National Committee on Uniform Traffic Control Devices

1
2 **National Committee on Uniform Traffic Control Devices (NCUTCD)**
3 **Recommended Changes to Proposed Text for 11th Edition of the MUTCD**
4 **Docket Number: FHWA-2020-0001**

5 **Federal Register Item Number:** 516

6 **NPA MUTCD Section Number:** Section 6P.01

Figure 6P-1. Work Beyond the Shoulder (TA-1)

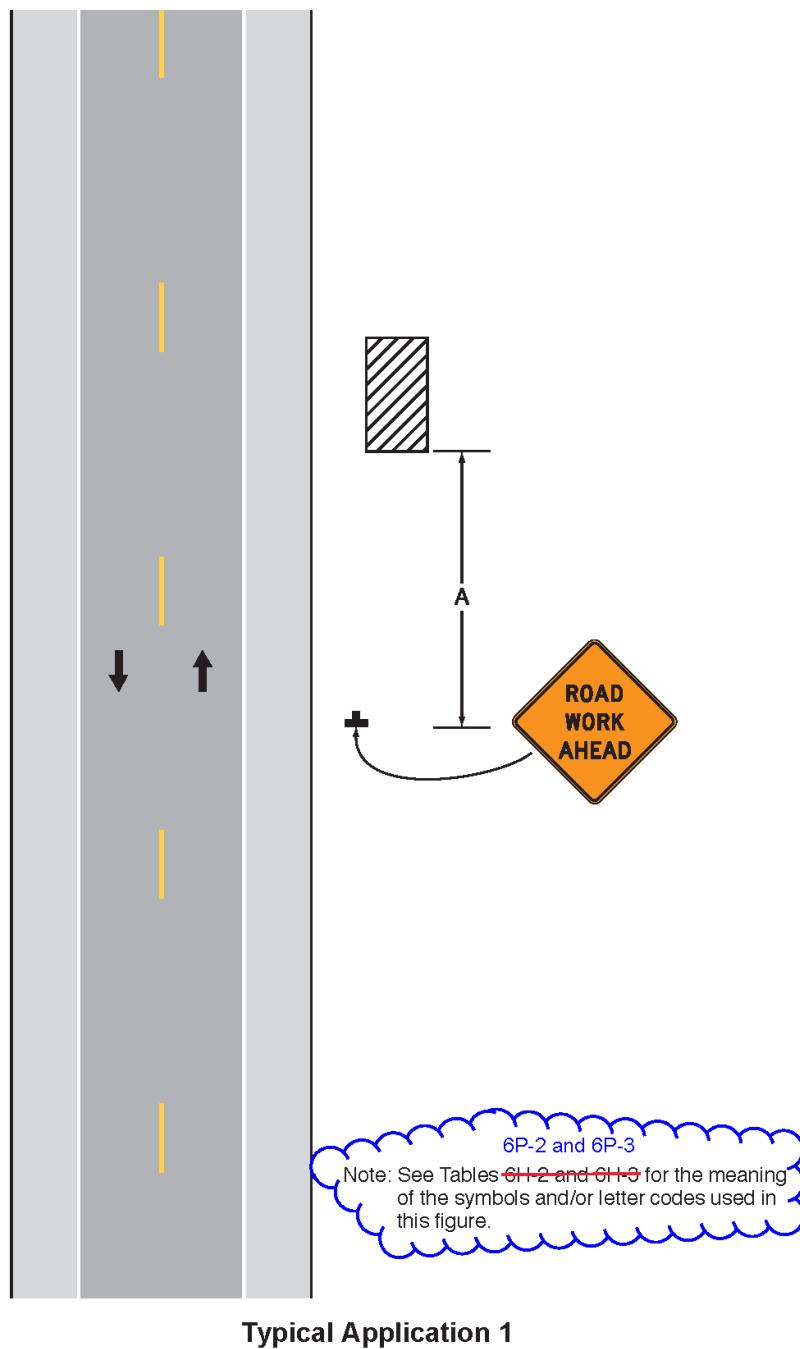
135 **Figure 6P-1 Comments:** NCUTCD generally agrees with Figure 6P-1 as presented in the NPA,
136 but recommends revising the references to Tables in the Figure note to correspond with the NPA
137 table renumbering.

170 **Figure 6P-2. Blasting Zone (TA-2)**

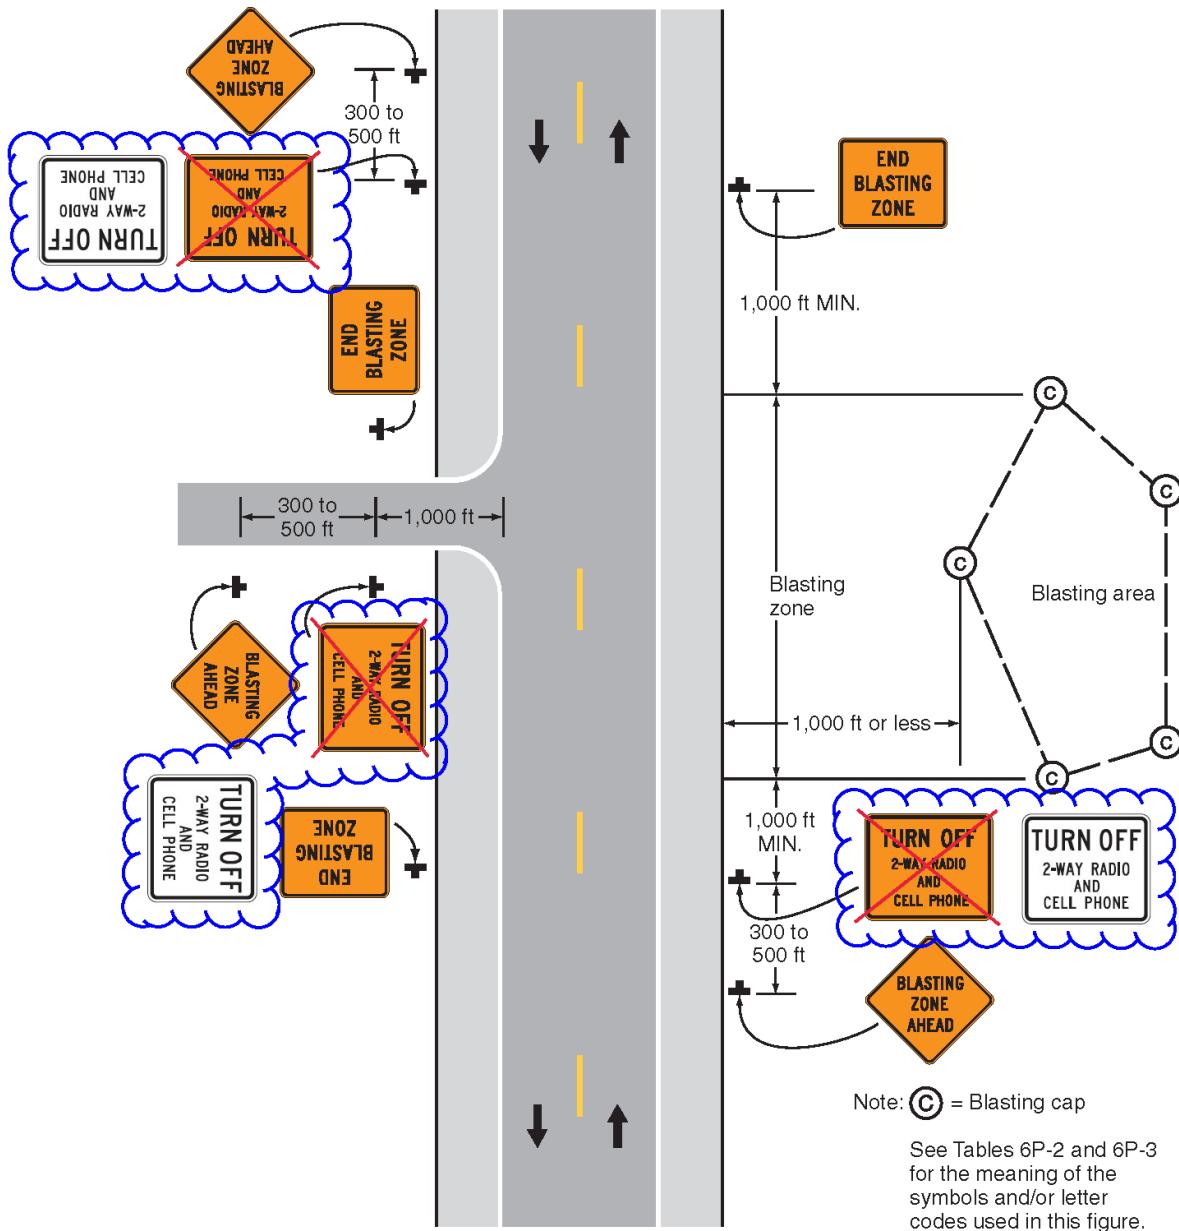
163 **Figure 6P-2 Comments:** NCUTCD generally agrees with Figure 6P-2 as presented in the NPA,
164 but recommends revising as follows:

- 165 • In the NPA the W22-2 TURN OFF 2-WAY RADIO AND CELL PHONE sign was
166 changed to regulatory R22-2 in Section 6G.11 and Figure 2G-1. For consistency with
167 Section 6G.11 and Figure 2G-1, the sign needs to be edited in Figure 6P-2.
- 168 • Revise the references to Tables in the figure note to correspond with the NPA table
169 renumbering.

212
213
214
215
216
217
218 **Figure 6P-3. Work on the Shoulders (TA-3)**

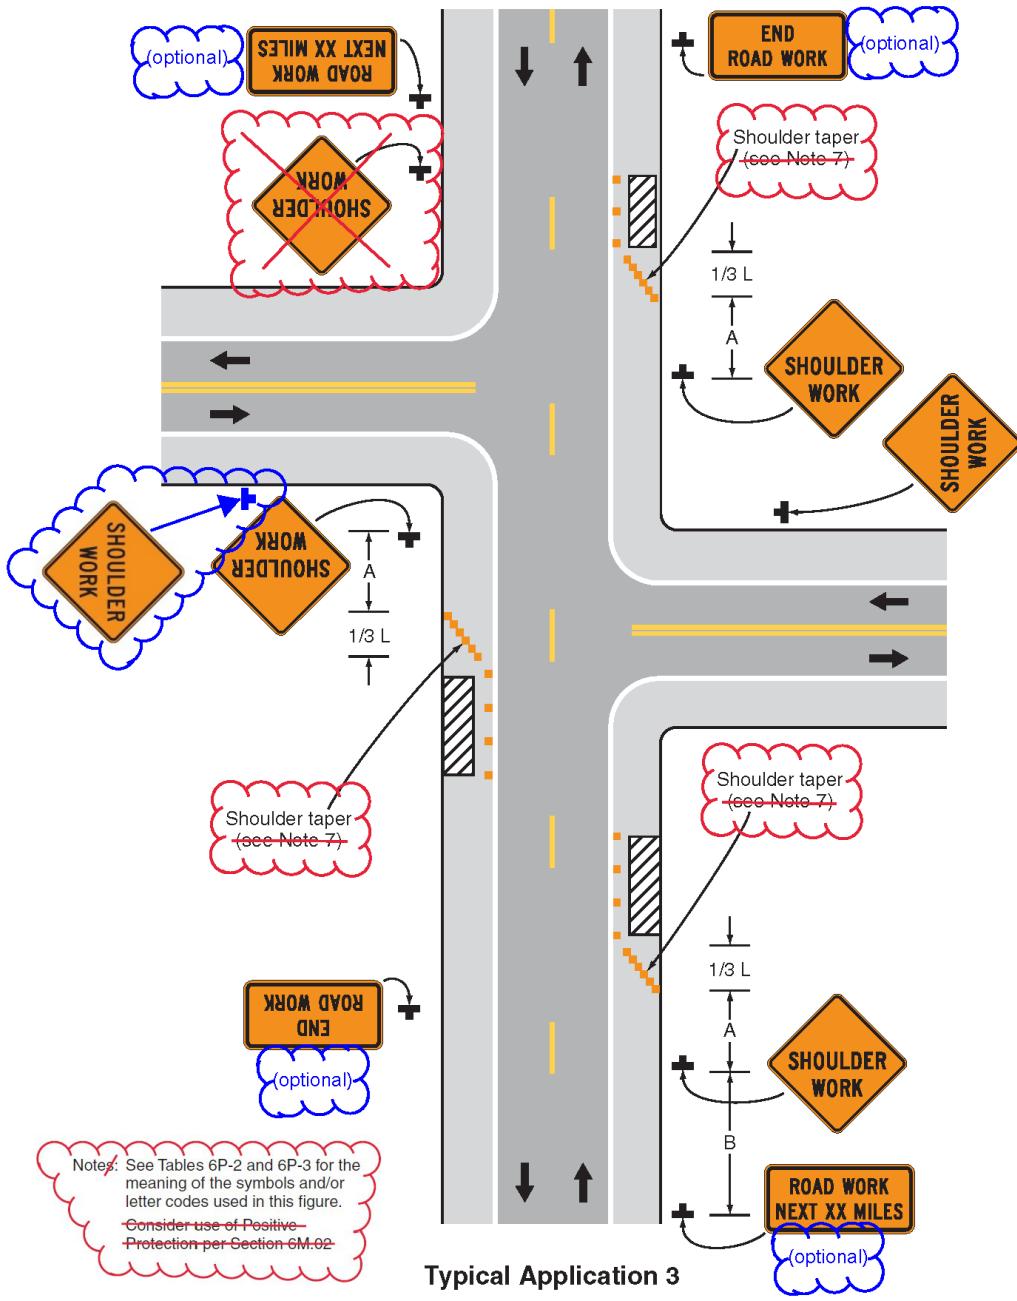
210 **Figure 6P-3 Comments:** NCUTCD generally agrees with Figure 6P-3 as presented in the NPA,
211 but recommends revising as follows:

270 **Figure 6P-4. Short Duration Short Duration or Mobile Operation on a Shoulder (TA-4)**
271

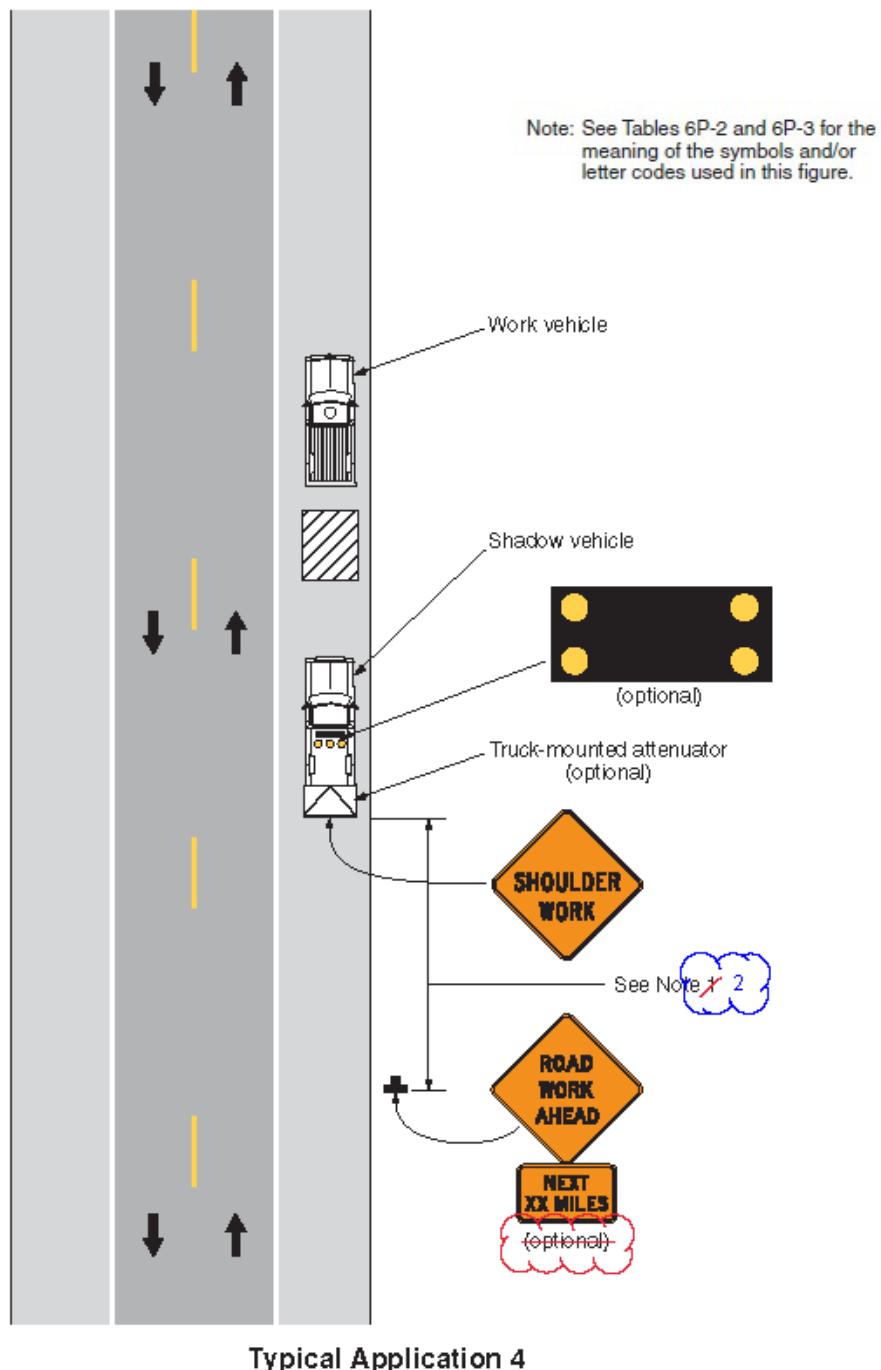
266 **Figure 6P-4 Comments:** NCUTCD generally agrees with Figure 6P-4 as presented in the NPA,
267 but recommends minor revisions in accordance with NCUTCD recommendation 20B-TTC-03,
268 including deleting the hyphen between 'Short' and 'Duration'.
269

Figure 6P-5. Shoulder Closure on a Freeway or Expressway (TA-5)

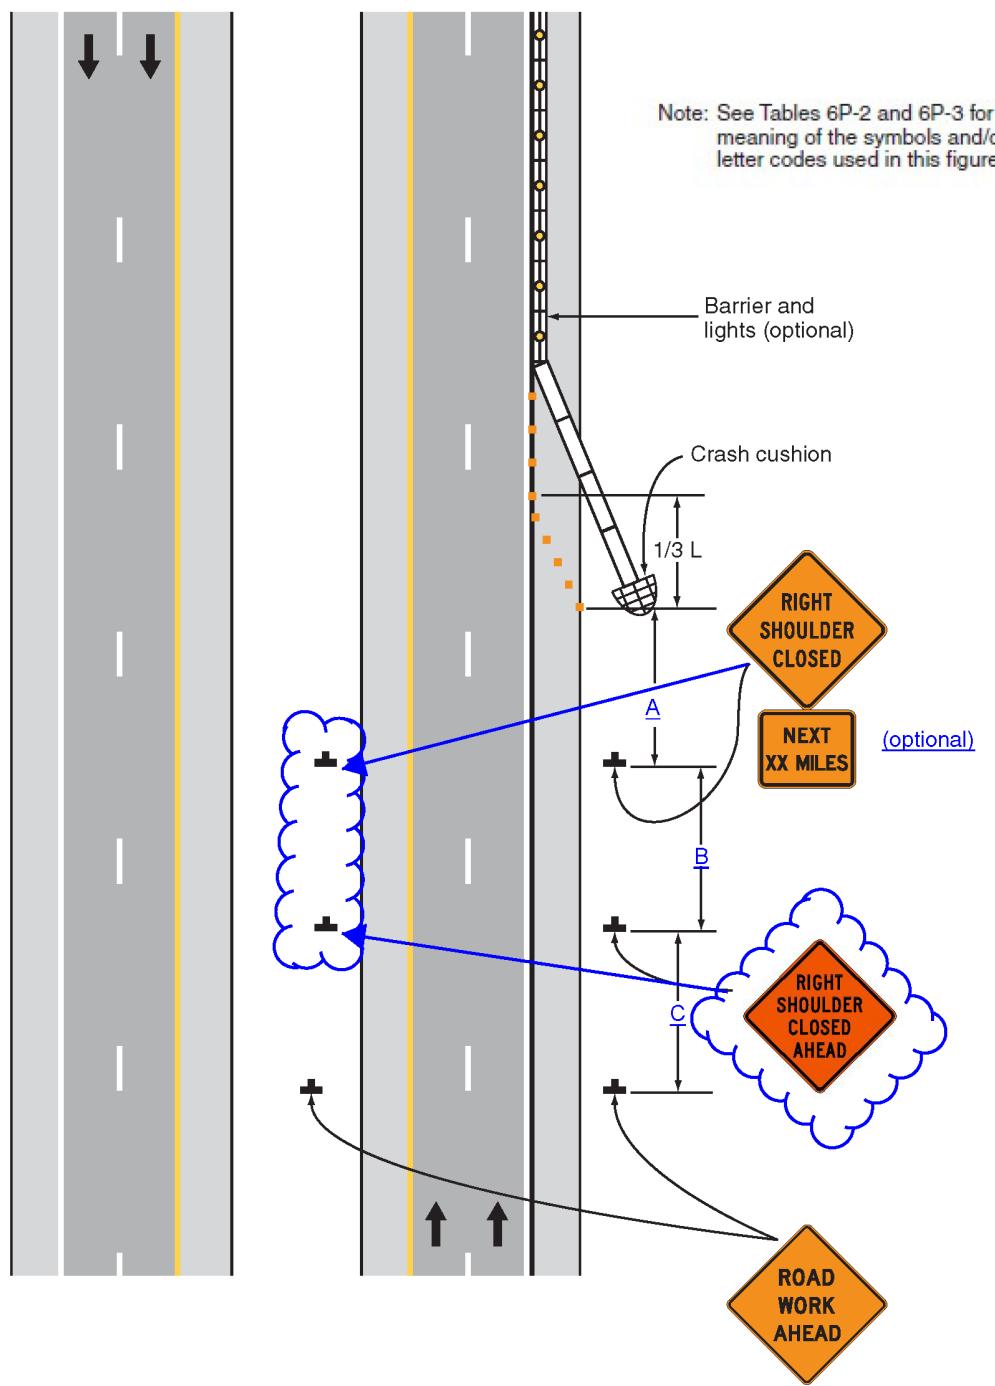
299 **Figure 6P-5 Comments:** NCUTCD generally agrees with Figure 6P-5 as presented in the NPA,
300 but recommends revisions in accordance with NCUTCD recommendation 20B-TTC-03,
301 including adding “or Expressway” to the title and placing signs on both the left and right sides of
302 the roadway.

365
366 **Figure 6P-6. Shoulder Work with Minor Encroachment (TA-6)**

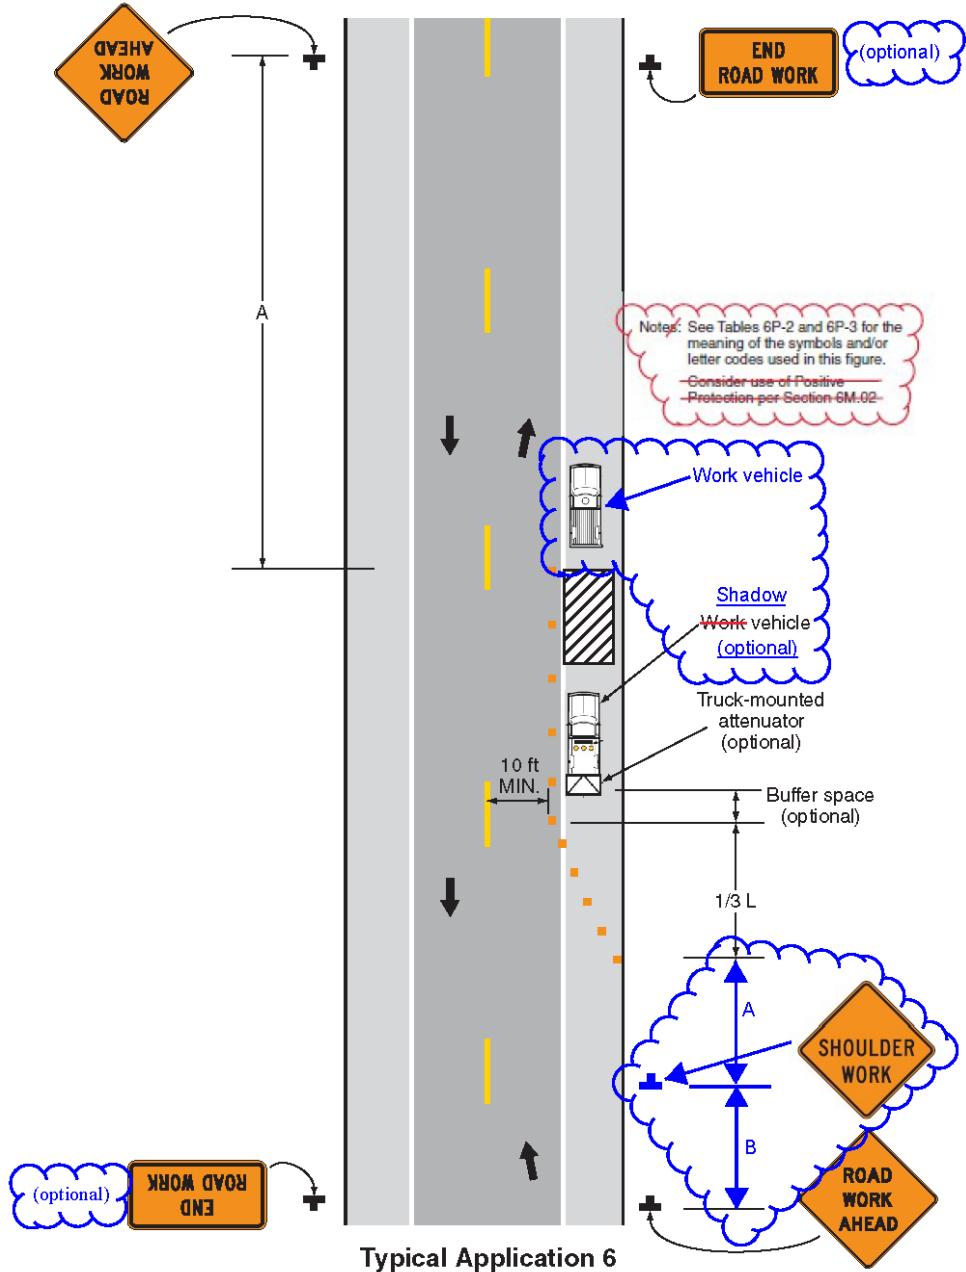
357 **Figure 6P-6 Comments:** NCUTCD generally agrees with Figure 6P-6 as presented in the NPA,
358 but recommends revisions in accordance with NCUTCD recommendation 20B-TTC-03:
359

515 **Figure 6P-10. Lane Closure on a Two-Lane Road Using Flaggers (TA-10)**

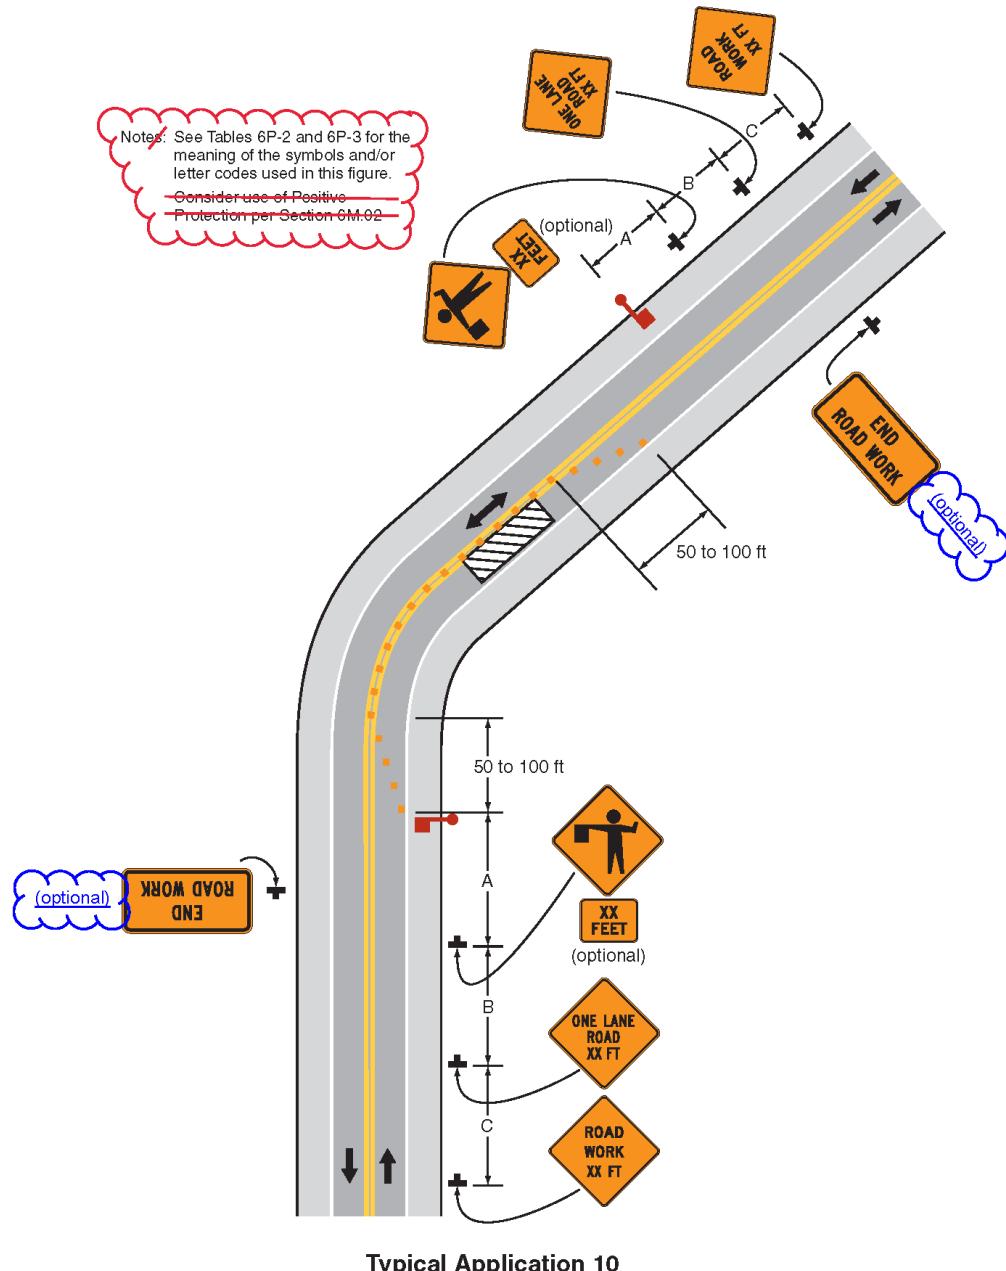
511 **Figure 6P-10 Comments:** NCUTCD recommends revising Figure 6P-10 in accordance with
512 NCUTCD recommendation 20B-TTC-02:
513 • Add “optional” to signs as appropriate
514 • Delete the positive protection note since it is redundant with a note added to the notes page

543 **Figure 6P-11. Lane Closure on a Two-Lane Road with Low Traffic Volumes (TA-11)**

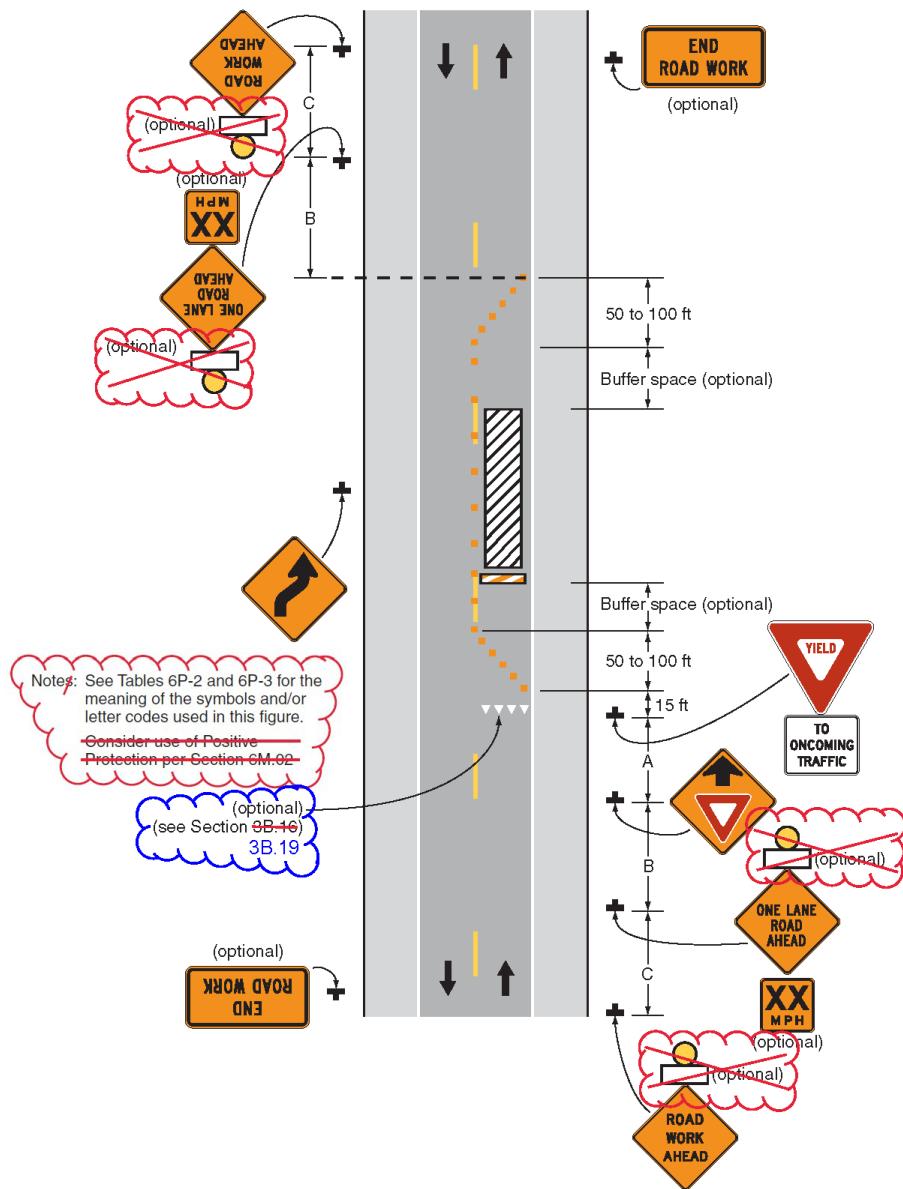
540 **Figure 6P-11 Comments:** NCUTCD generally agrees with Figure 6P-11 as presented in the
541 NPA, but recommends the following in accordance with NCUTCD recommendation 20B-TTC-
542 02:
